Subject: **Request for Modification to Individual Section 404 Permit and to Individual Section 401 Certification for Section R-2519A**
US 19/US 19E Improvements from SR 1336 (Jacks Creek Road) to SR 1186 (US 19) west of Micaville Yancey County NCDOT Division 13
State Project Numbers 6.869005T and 6.909001T
T.I.P. Project Number R-2519A
Debit \$570.00 from WBS Element 35609.1.1

This letter addresses modifications to Section R-2519A of the US 19E widening project that extends from SR 1336 (Jack's Creek Road) to SR 1186 (US 19) west of Micaville. The North Carolina Department of Transportation (NCDOT) requests approval for revisions to the Individual 404 Phased Modification issued January 1, 2010 and the Individual 401 Phased Modification issued September 4, 2009. NCDOT proposes to eliminate a proposed retaining wall depicted on Permit Drawings page 37 and 38 (Permit Site 12) and Roadway Plan Sheet 20.

Permit Drawings
Sheet 6 of 86
Revised 10/03/14

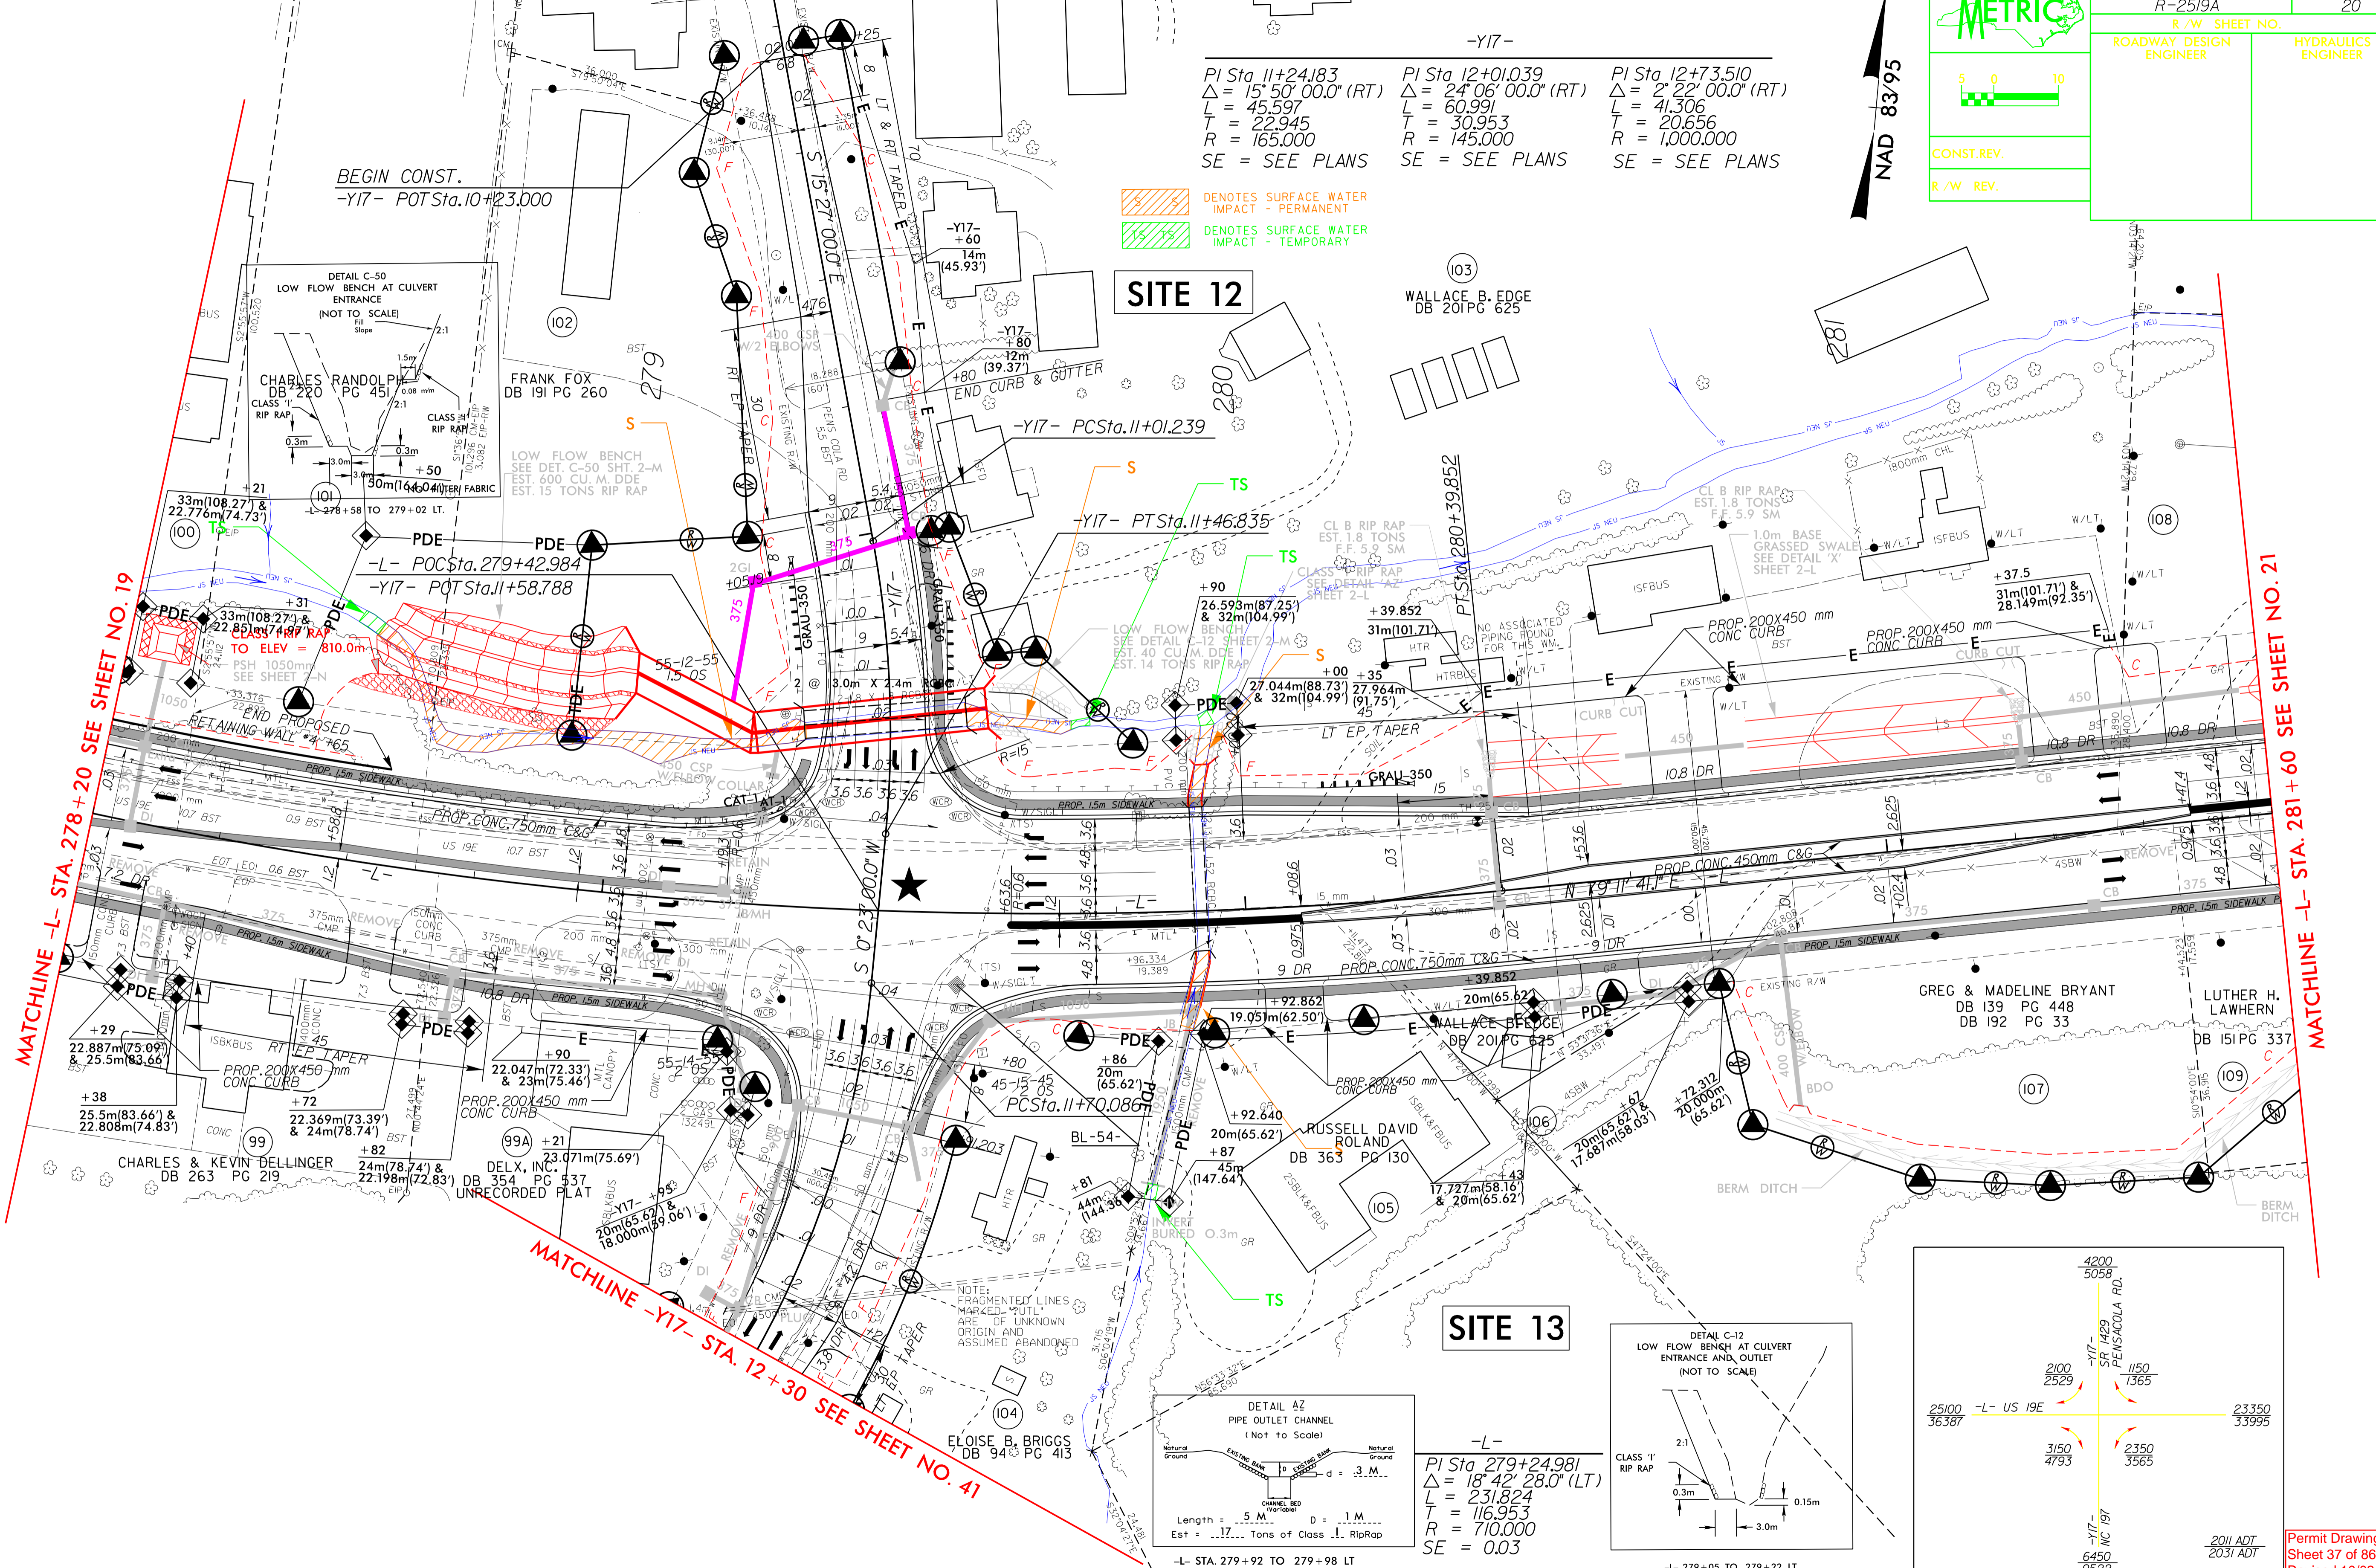
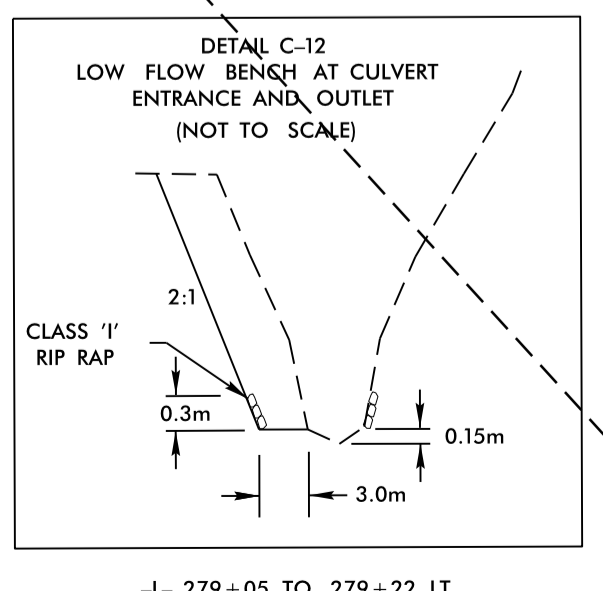
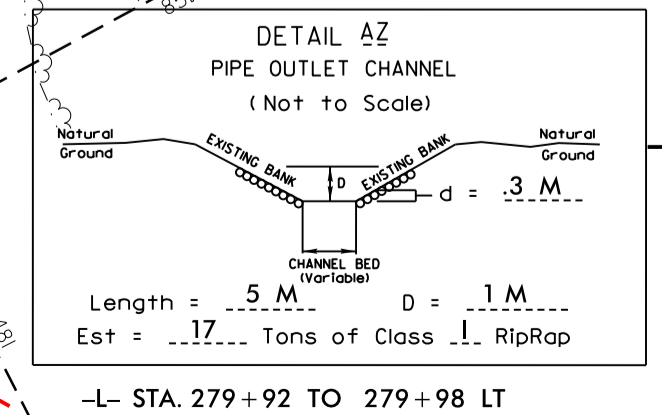
Permit Site 12 is located near the intersection of Pensacola Road (NC 197) and US 19 E where Little Crabtree Creek passes through an existing double barrel culvert. The discovery of a bedrock layer along Little Crabtree Creek has prevented the installation of the proposed retaining wall. As a result, NCDOT proposes a 2:1 fill slope at this location which will encroach upon Little Crabtree Creek necessitating the realignment of the stream and the extension of the culvert under Pensacola Road.

The revised permanent impacts at Site 12 are **305 linear feet**, an increase of 173 linear feet over the original estimated impacts of 132 lf (34 lf culvert extension/98 lf of bank stabilization).

PROJECT REFERENCE NO.	R-2519A	SHEET NO.	20
R/W SHEET NO.			
ROADWAY DESIGN ENGINEER	Roadway Plansheet 20 Revised 10/03/2014		
HYDRAULICS ENGINEER			
CONST. REV.			
R/W REV.

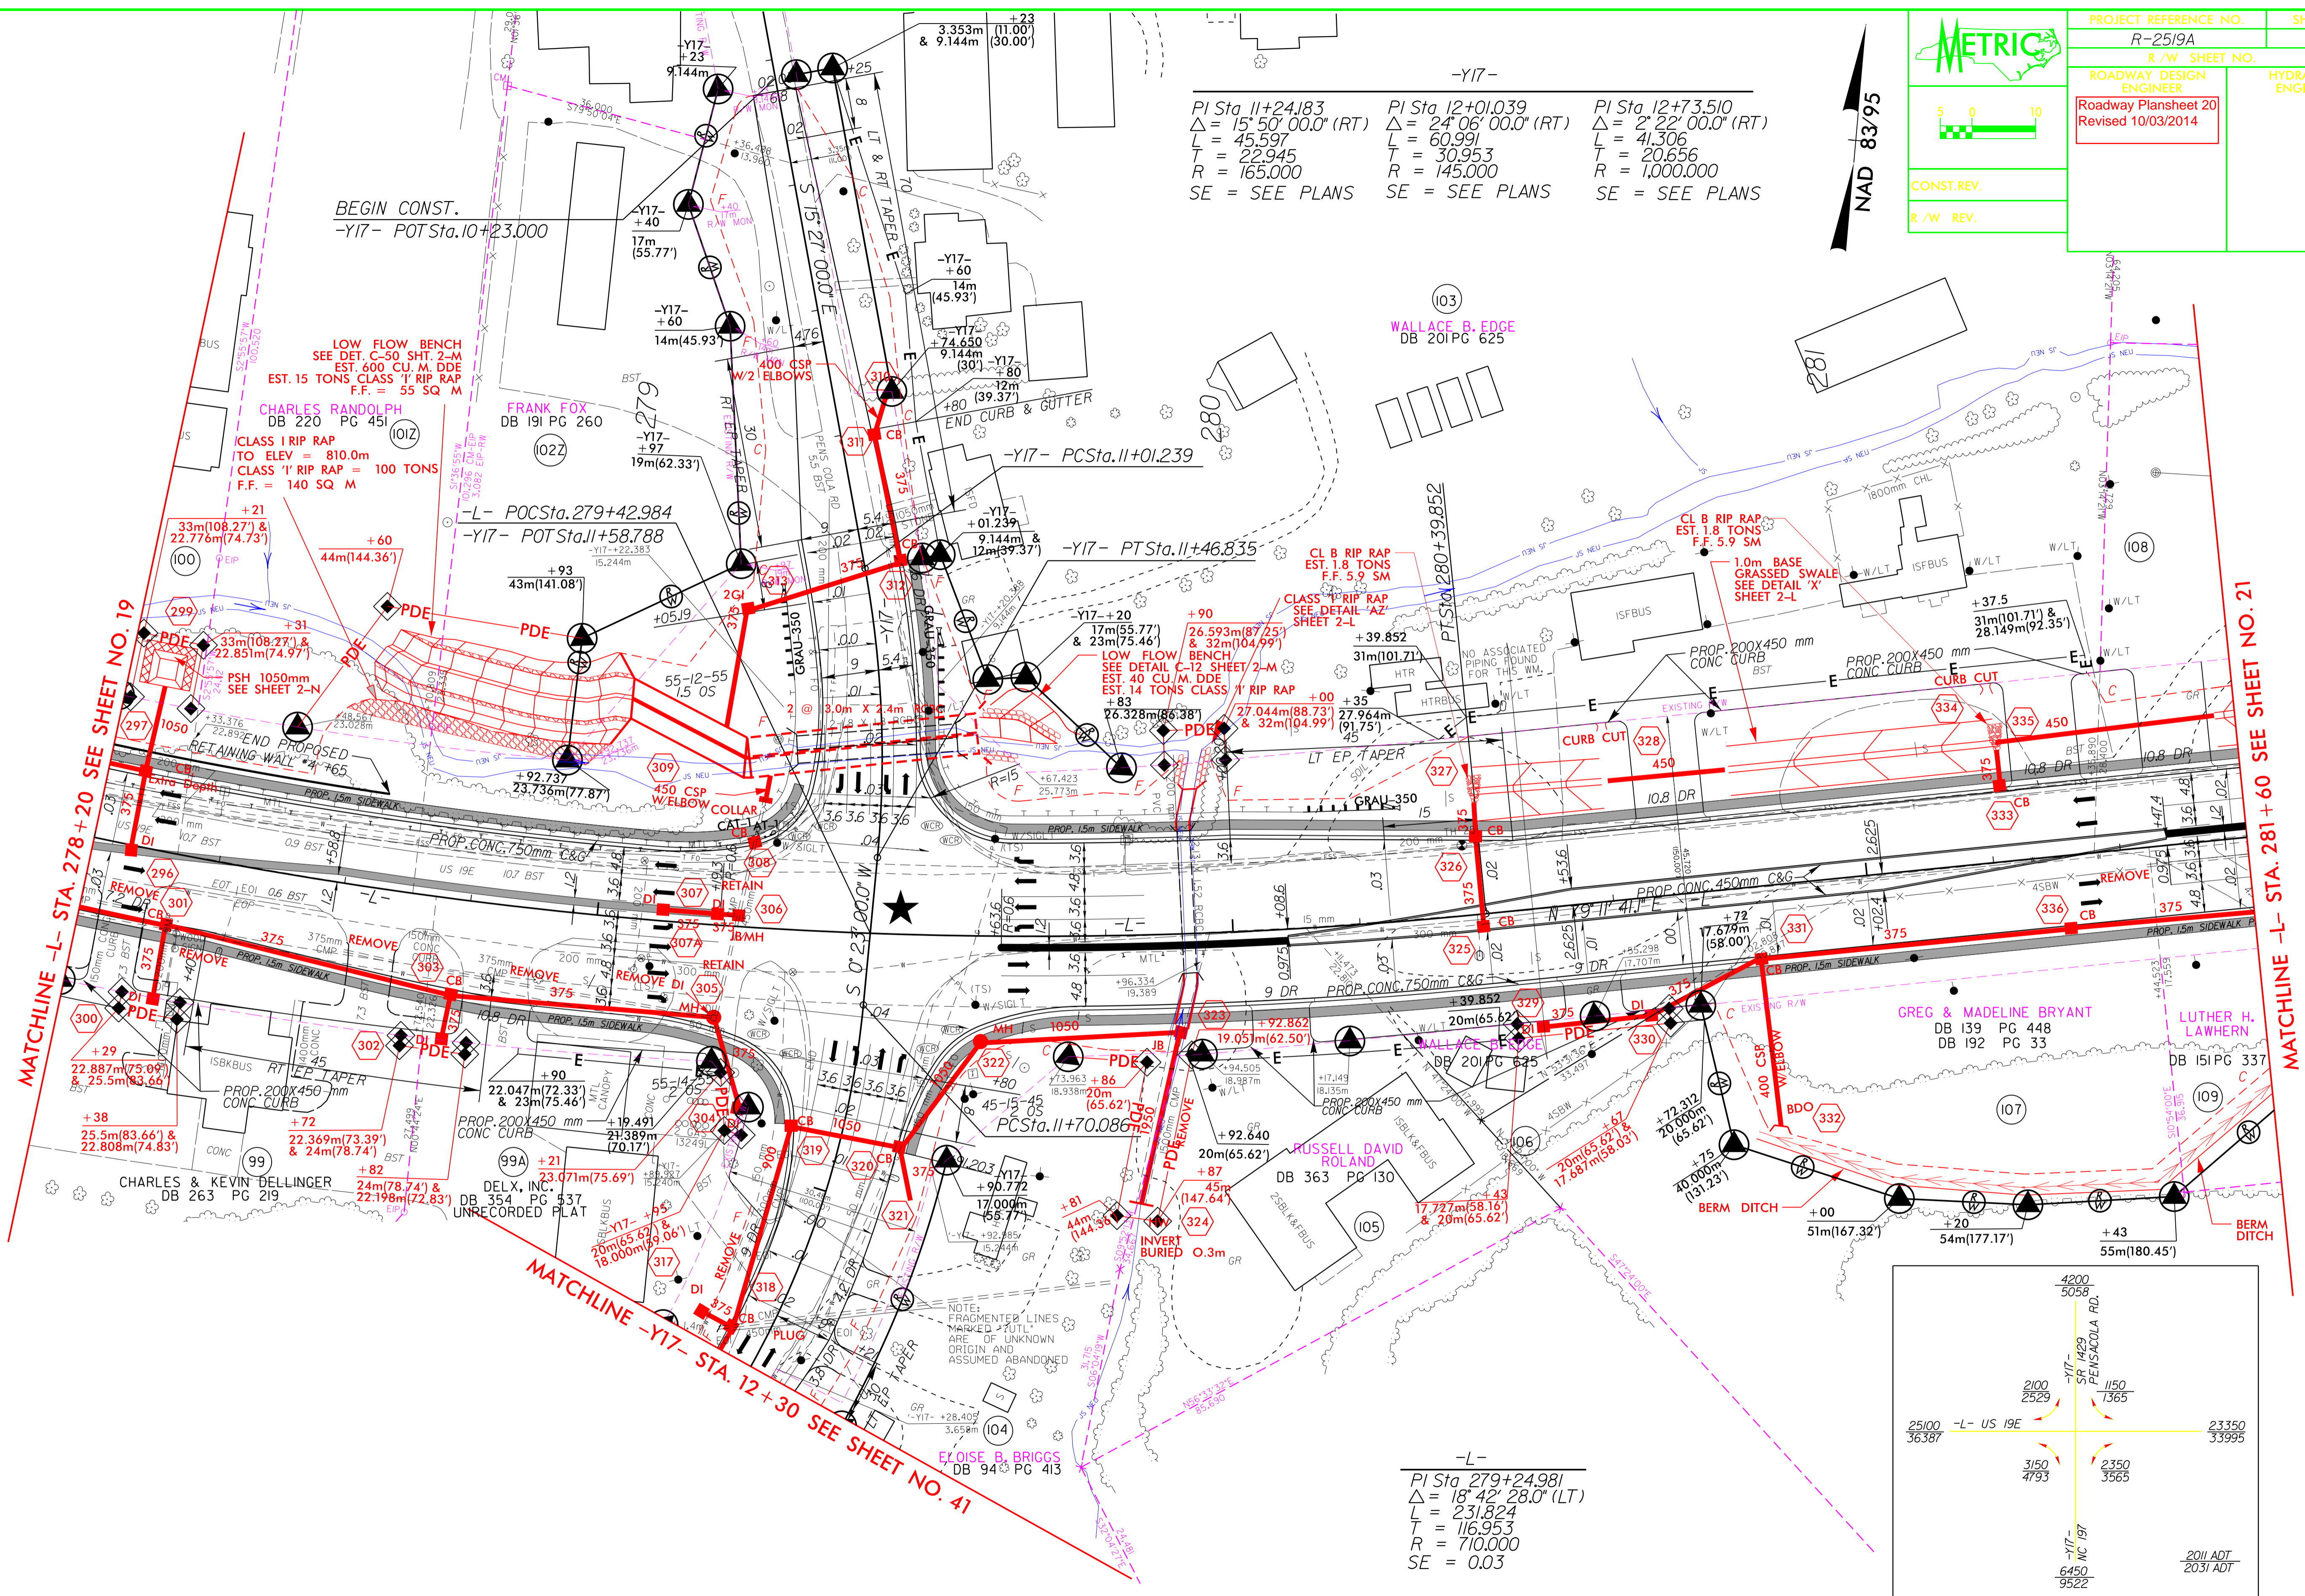
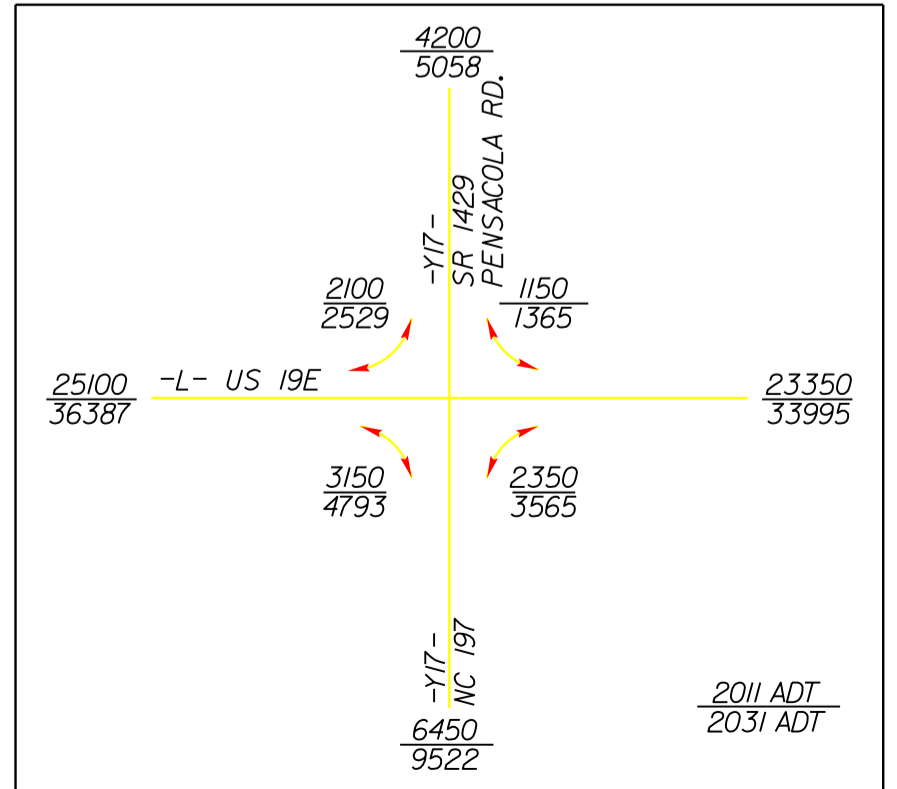
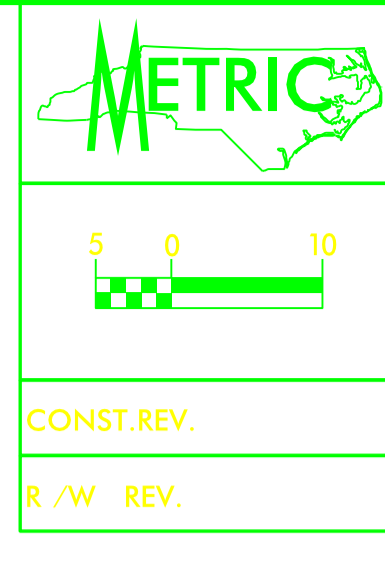
CONST. REV.: REVISED CULVERT UNDER -Y17- AND ADDED A LOW FLOW BENCH ON PARCEL 101Z AND 102Z.
